Regarding: Unit B/C - Health Sciences Expansion
Delaware Street and Church Property

Re: Unit B/C Health Science Complex
Minneapolis Campus

I have completed the preliminary review of the plans only for the above project and I have the following comments.

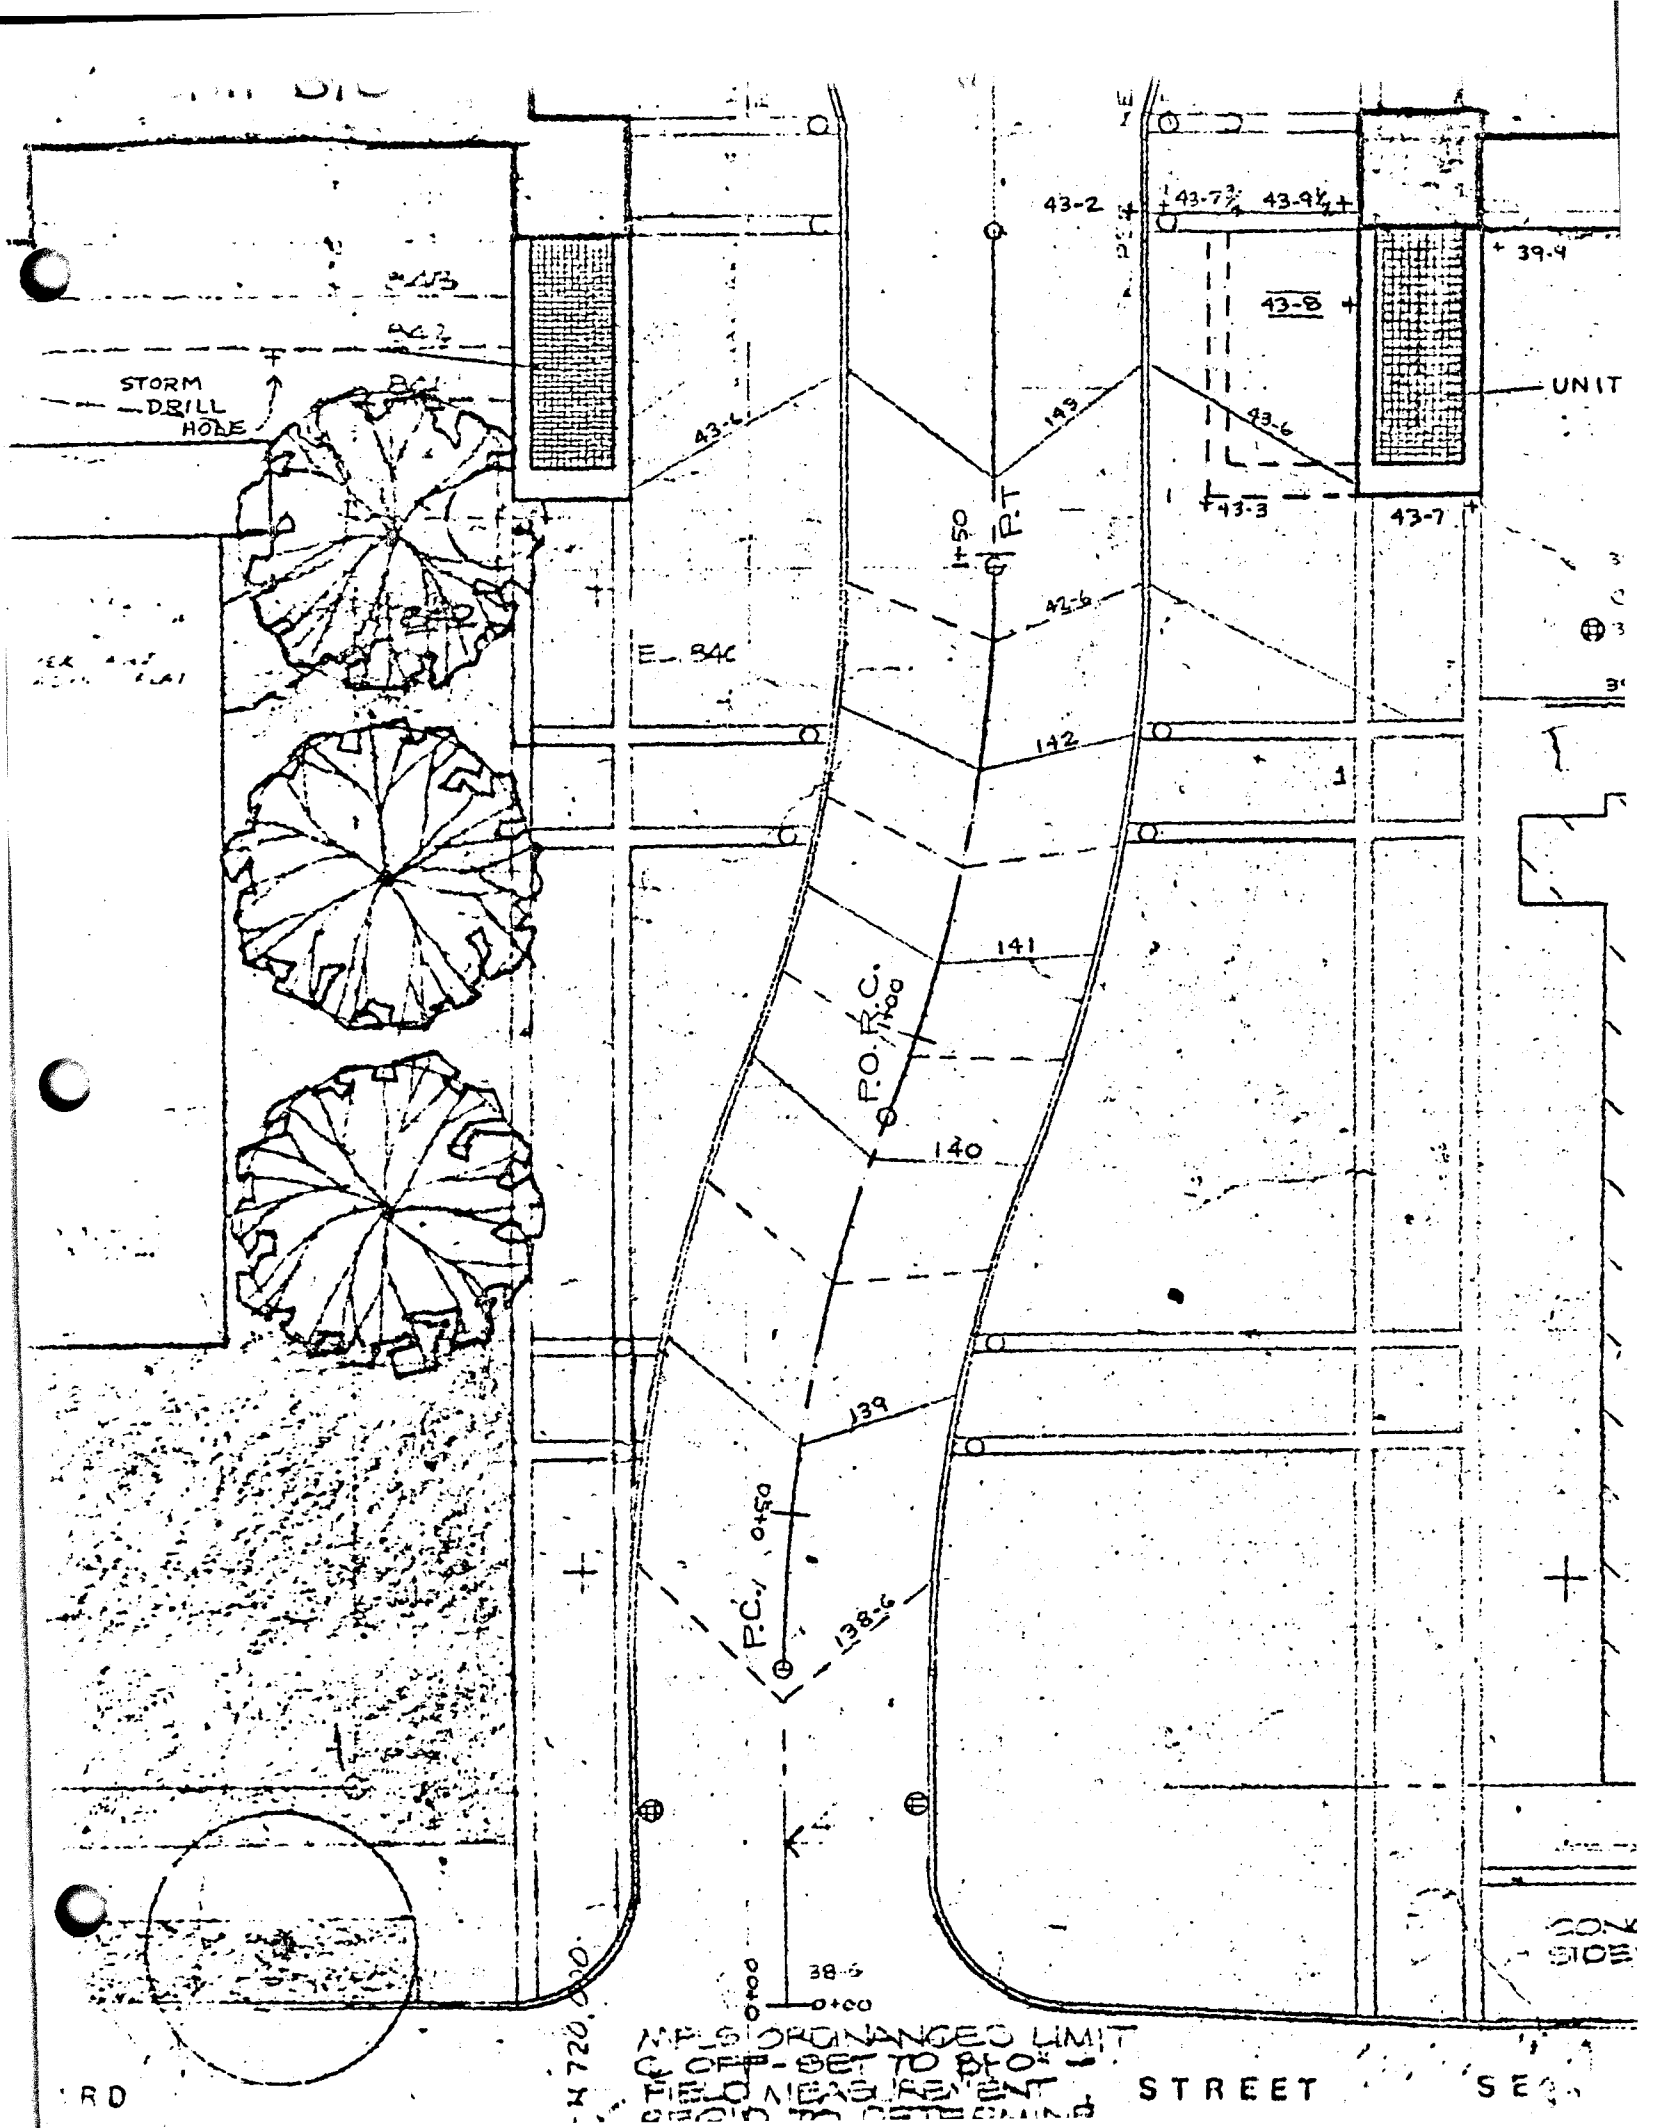
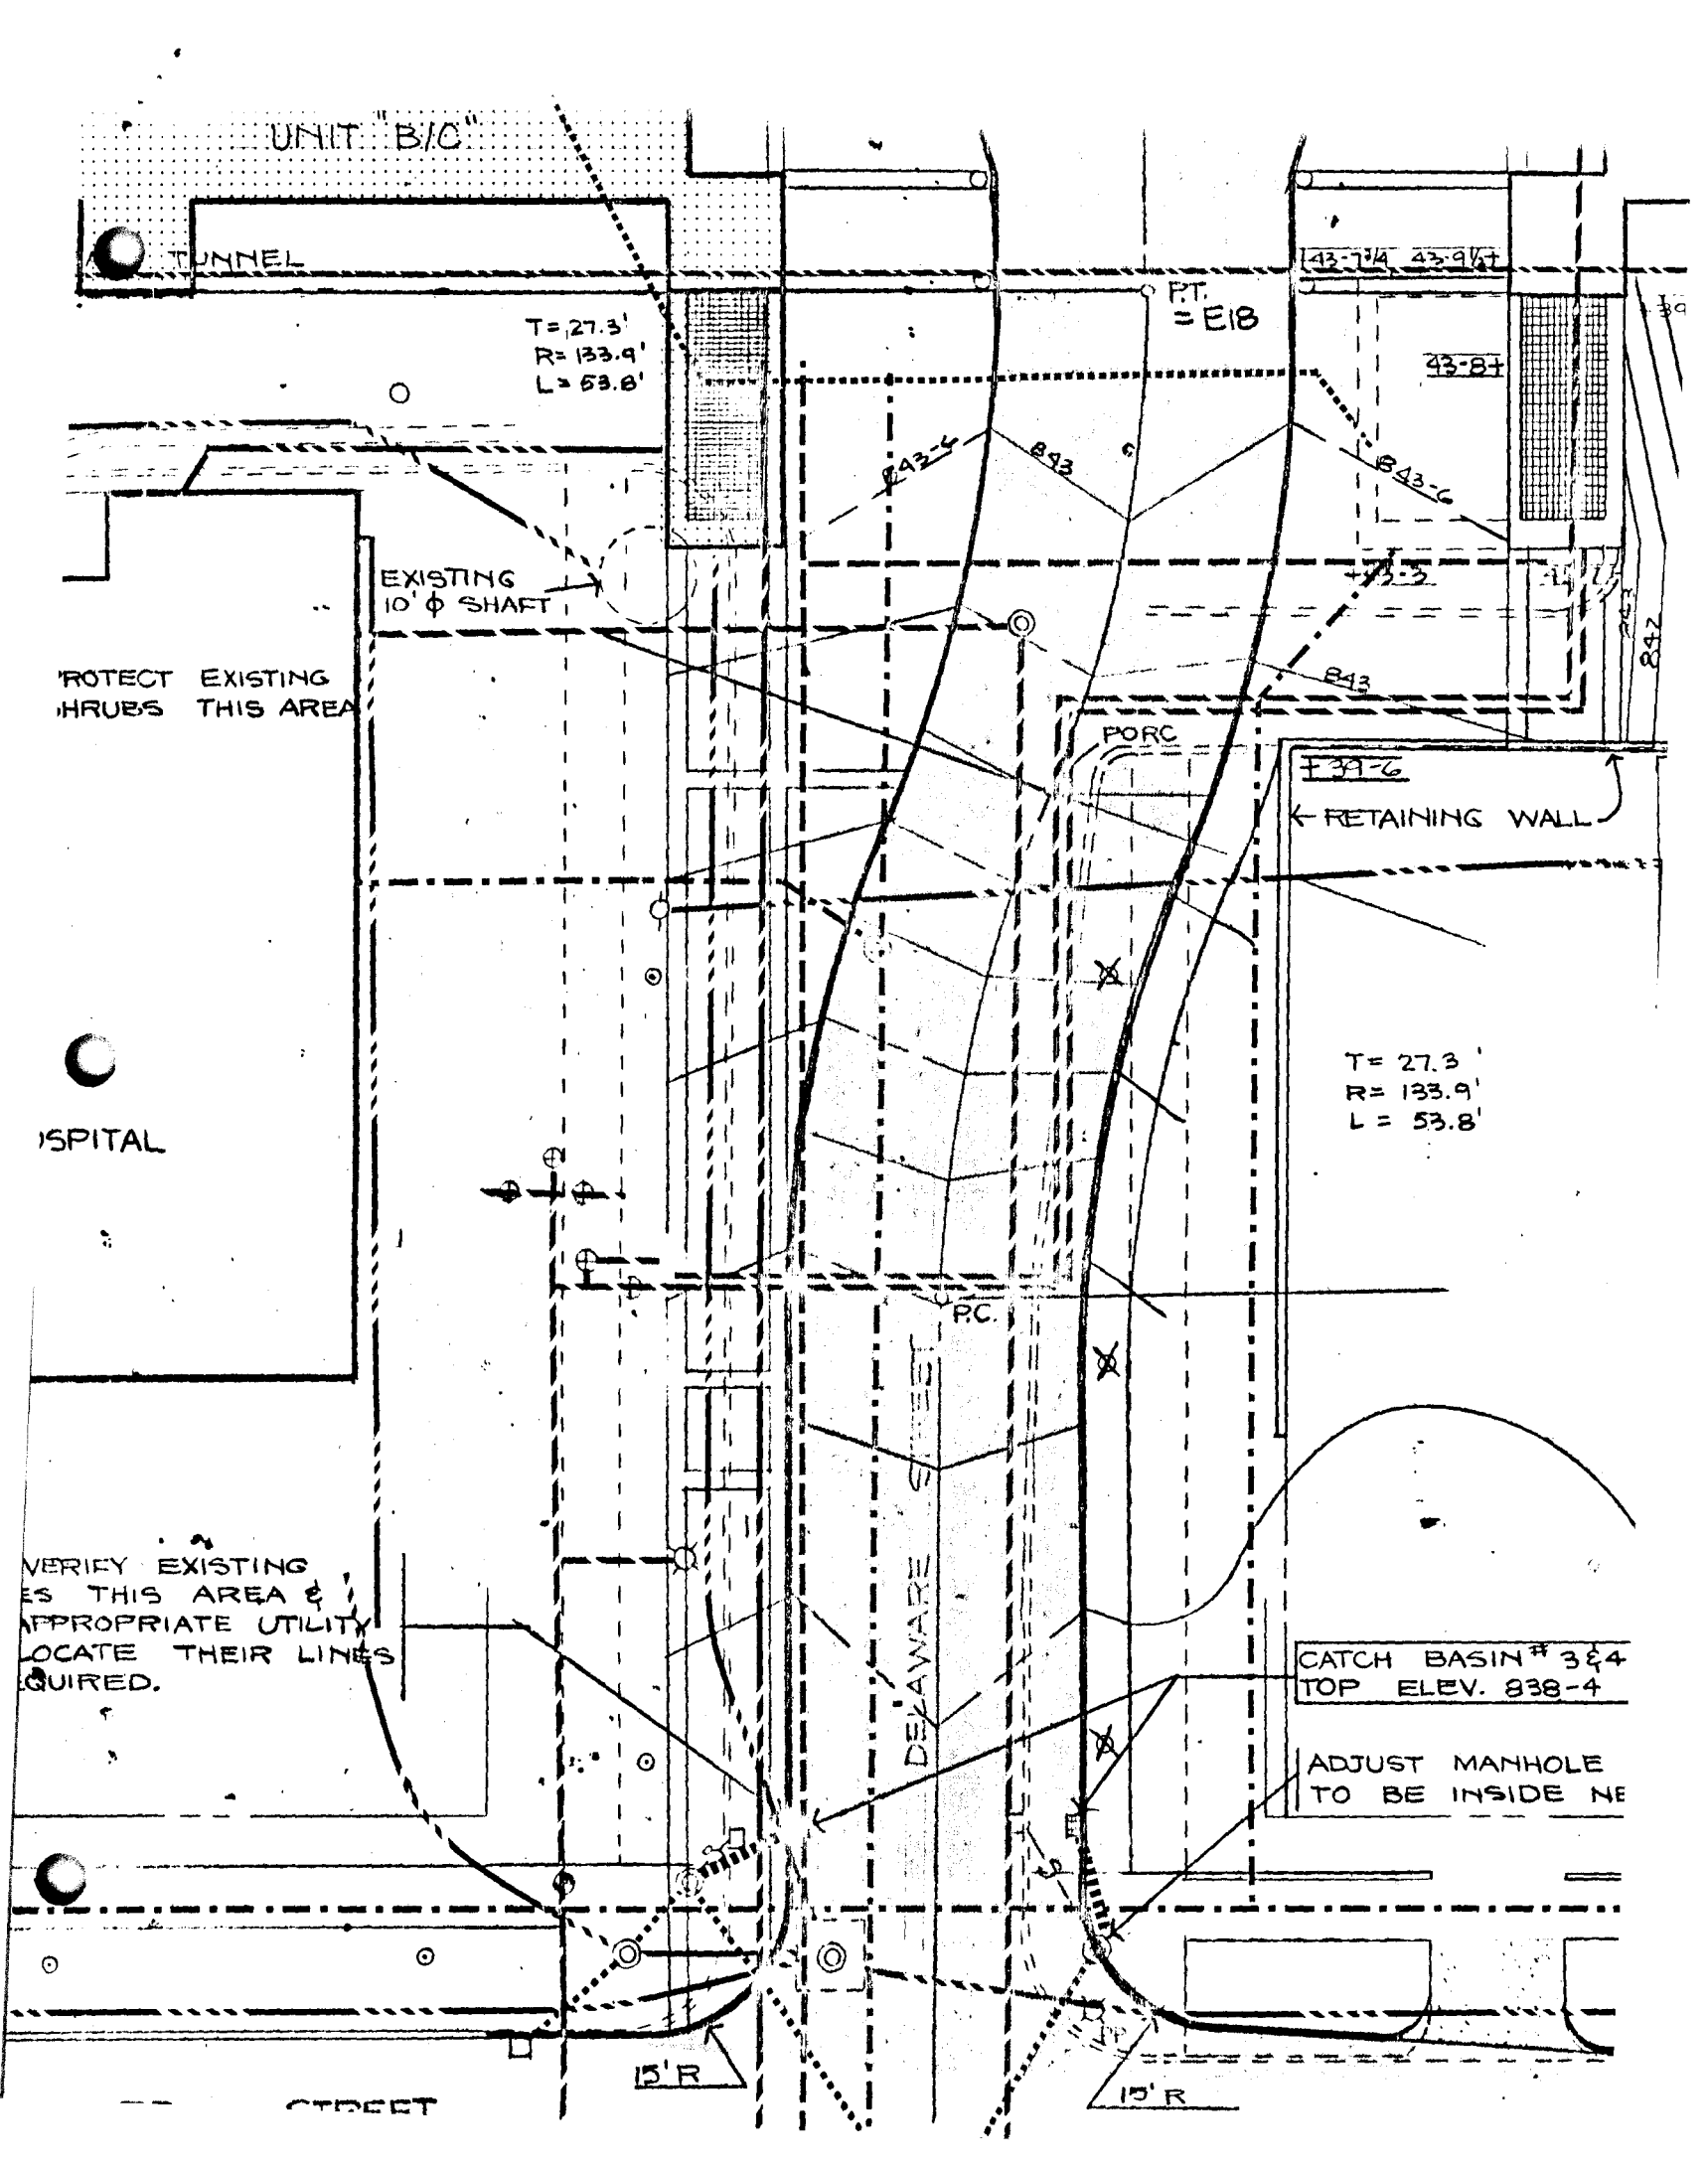
The 1971 Design Development Documents had developed the Delaware Street Entrance to the Health Sciences Complex based upon the premise that the Church parking lot property would be available for the overall entrance development. Enclosed is a sketch indicating the proposed entrance provisions. The referenced drawing indicates Delaware Avenue with a curvilinear alignment which forms a pleasing transition for the parallel offset which is required West of Harvard Street. A simple and simple-reverse curve of equal radius are used to accomplish the alignment change and are located approximately equal distance between Harvard Street and Units A and B/C. This street curvature provides a desirable tangent balance between the surface feature changes at Harvard Street and the street widening that occurs between Units A and B/C. The continuity of the Plaza dimensions and materials are extended to Harvard Street to further enhance the primary entrance to the Health Sciences Complex.

We understand that the University does not wish to encroach upon the church property at this time. We have therefore developed an entrance design outside the limits of the church property. This design parameter necessitates a shift in the street curvature to the west resulting in a less comfortable vehicular pathway through the required offset. A retaining wall on the south and west property line of the church will be required to accommodate the grade changes. The north sidewalk will be restricted to approximately 5 feet of width at the southwest corner of the church property.

We are not comfortable with the current design and hope that this layout can be changed to the design development layout in the near future. We urge and recommend that the University seriously pursue a property change so that the design development plan can be incorporated into the project by change order prior to any construction in this area. Please let us know if you need any assistance in resolving this recommended property change.
